# UNITED STATES PATENT AND TRADEMARK OFFICE

APPLICATION NO.	FILING DATE	FIRST NAMED INVENTOR	ATTORNEY DOCKET NO.	CONFIRMATION NO.
09/496,374	02/02/2000	Masami Kidono	OOCL-11 (11P024627)	6123
26479	7590	06/30/2004	EXAMINER PIZIALI, JEFFREY J	
STRAUB & POKOTYLO 620 TINTON AVENUE BLDG. B, 2ND FLOOR TINTON FALLS, NJ 07724			ART UNIT 2673	PAPER NUMBER 21

## Office Action Summary

## **DETAILED ACTION**

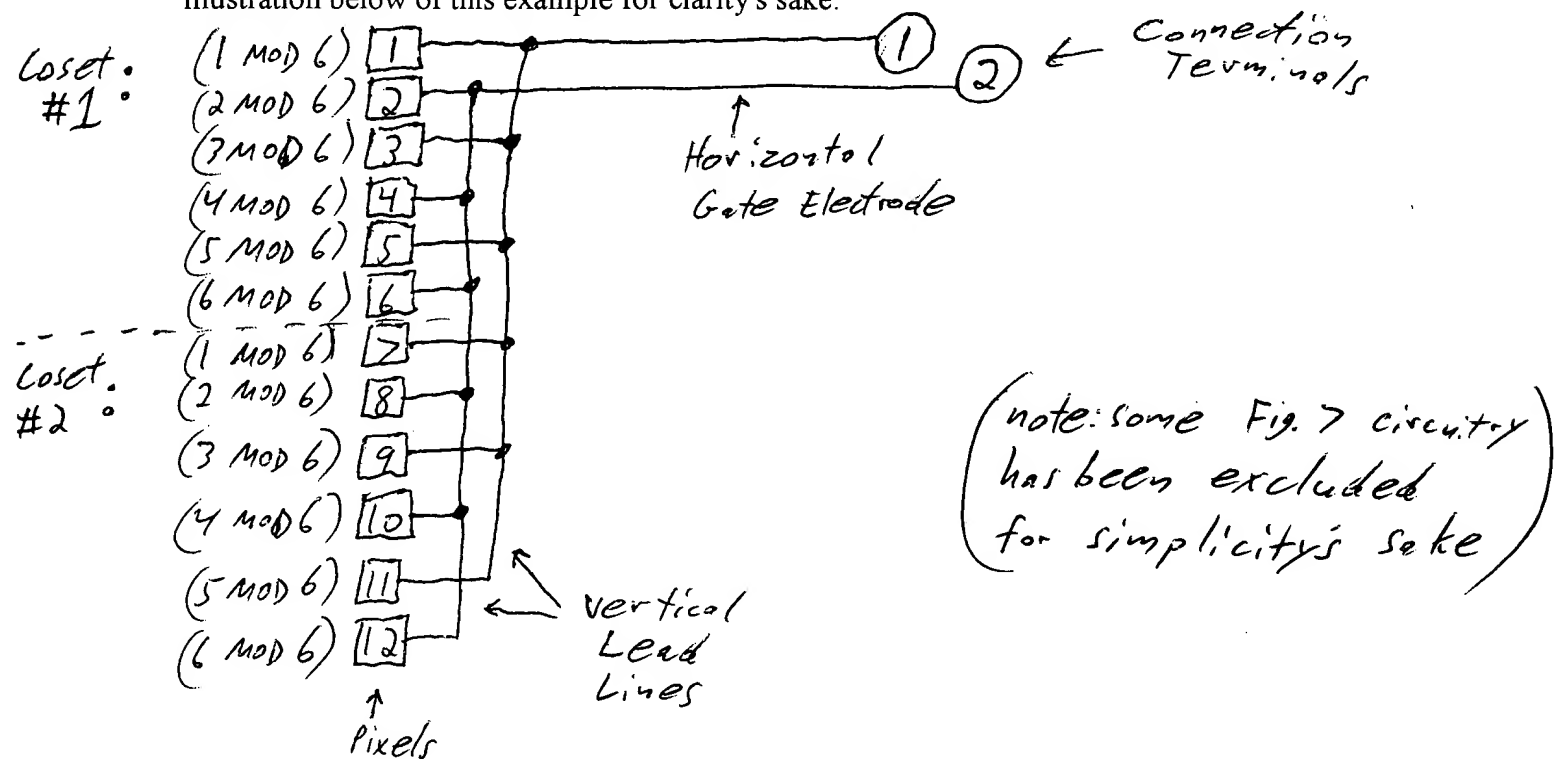
5. Applicants' arguments filed 3 June 2004 (Paper No. 21) have been fully considered but they are not persuasive. The applicants contend that the current application's own admitted prior art does not teach a plurality of lead lines for connecting the gate electrodes to an external circuit and a plurality of connection terminals for connecting the gate electrodes to the external circuit. However, the examiner respectfully disagrees. The prior art Figure 7 illustrates a plurality of lead lines [Fig. 7, 4A -- vertical lines] for connecting the gate electrodes [Fig. 7, 4A -- horizontal lines] to an external circuit and a plurality of connection terminals [Fig. 7, 6] for connecting the gate electrodes to the external circuit (see Page 2, Line 15 - Page 5, Line 6).

Additionally, the applicants contend that the current application's own admitted prior art does not teach the gate electrodes making up N of gate electrode groups in which the lines belonging to each coset of modulo N within successive pixel rows are connected to common lead lines. However, the examiner must again respectfully disagree. Although Figure 7 illustrates an imaging device with 16 connection terminals; the examiner, for reasons of brevity and conceptual simplicity, will instead rely upon an example duplicating Figure 7's pixel-to-terminal wiring design, but only comprising two connection terminals. It is noted however, the following example circuitry arrangement can be easily extrapolated to include 16 (or more) connection terminals -- increasing the modulo and complexity accordingly.

In this example, there are twelve pixels [Fig 7; 1]. Two connection terminals [Fig. 7; 6]. The gate electrodes [Fig. 7; 4A - horizontal lines] making up six (where  $N = 6$ ) of gate electrode groups -- effectively dividing the twelve pixels total into two separate cosets of six pixels each. Connection terminal #1 is connected to odd-numbered pixels 1, 3, 5, 7, 9, & 11. Connection

terminal #2 is connected to even-numbered pixels 2, 4, 6, 8, 10, & 12. That is, in other words, connection terminal #1 is connected to pixels 1 MOD 6, 3 MOD 6, & 5 MOD 6; and connection terminal #2 is connected to pixels 2 MOD 6, 4 MOD 6, & 6 MOD 6 -- this remains true for the first coset of 6 pixels as well as the second coset of 6 pixels. The examiner has included a rough illustration below of this example for clarity's sake.

Following from the above example, it is clearly evidenced that current application's own admitted prior art does teach the gate electrodes making up N of gate electrode groups in which the lines belonging to each coset of modulo N within successive pixel rows are connected to common lead lines. The above example, with only 2 *connection terminals* and 12 *pixels*, is *modulo 6*. However, Figure 7, with 16 *connection terminals* and 544 *pixels*, would be *modulo 272*. By such reasoning, rejection of the claims is deemed necessary, proper, and thereby maintained at this time.
